Memorandum

From: Aubrey L. Strause, PE and Craig Burgess, PE (Acorn Engineering, Inc.)
Date: December 4, 2023
Subject: Preliminary Subdivision Application – Wildes District Road Subdivision
Beachwood Development Fund, LP
Tax Map 9, Lot 10-23
Kennebunkport, Maine 04046

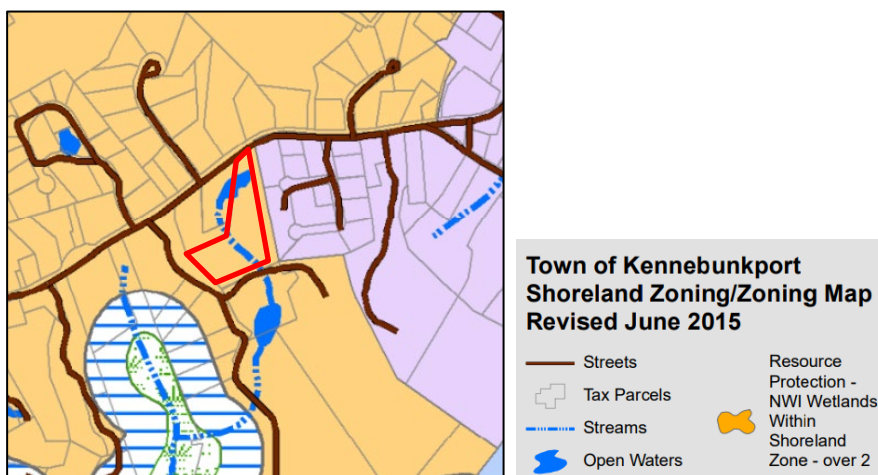
15. A large pond is located partially on the subject property (Tax Map 9, Lot 10-23) and partially on the adjacent property (Tax Map 9, Lot 10-22-A), which is owned by the same person as the subject property. Acorn estimates that the pond has an overall water surface area of approximately 36,000 SF based upon the water surface line depicted on Sheet C-2.0. This is greater than the 20,000 square feet threshold that Maine DEP considers a freshwater Wetland of Special Significance (WOSS) per Rule Chapter 310.4.A(5)⁶, which is inset below.

During the 11/15/23 Planning Board meeting, the engineer stated that the pond was determined to be “man-made”. The application should include information about how this determination was made, by whom, and provide documentation demonstrating that the Maine DEP was consulted and concurred with this determination.

If it cannot be demonstrated that the pond is man-made, it would be considered a wetland of special significance per Chapter 310.4(5) language and could have substantial impact on the proposed design.

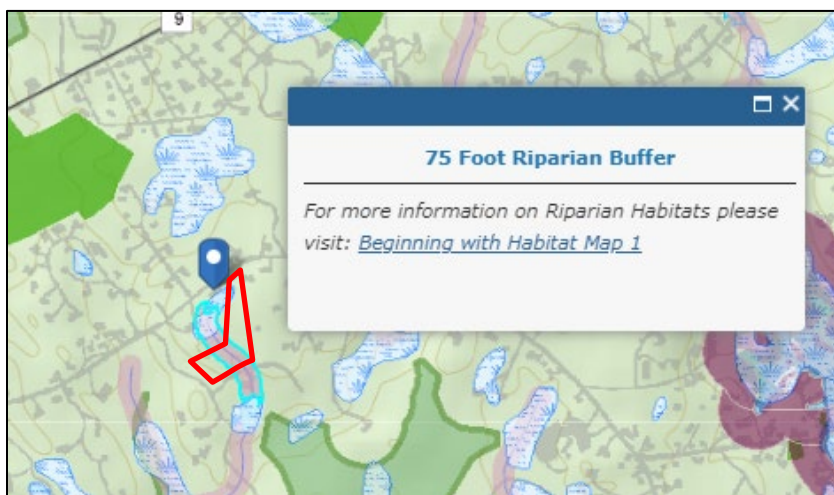
16. The Existing Conditions Plan (Sheet 1 of 1) shows a feature labeled “ditch” that extends from the outlet of the pond on Lot 10-22-A and crosses Lot 10-23.

This feature is labeled as a “30-foot-wide drainage easement” on Revised Sheet C-2.0 (11/27/23) but no drainage easement is mentioned in the recorded deed (York County Registry of Deeds, Book 16177 Page 988). Within the drainage easement shown on Revised Sheet C-2.0, the feature is shown as wetlands (type not specified).

The USGS Quadrangle⁷ for this area (image inset below, with the subject parcel outlined in red), the feature is shown as a “blue line” which is an indicator of a potential stream.

The Town’s Zoning and Shoreland Zoning Map⁸ (image inset below, with the subject parcel outlined in red) also shows this as a stream.

The Maine Department of Inland Fisheries and Wildlife (MDIFW) also considers this feature to be a stream in its Beginning with Habitat online map viewer⁹ (image inset below, with the subject parcel outlined in red) and requests maintaining a 75-foot riparian habitat buffer around it.

The Natural Resource Protection Act (NRPA) Identification Guide for Rivers, Streams and Brooks¹⁰ lists five characteristics of a stream. To be considered a stream, the feature must have a defined channel and two of the five characteristics; this feature does have a defined channel and appears to have at least two of the five characteristics

The application shall include information about who performed the field determination of the feature, address each of the NRPA Identification characteristics, and provide documentation demonstrating that the Maine DEP was consulted and concurred. Otherwise
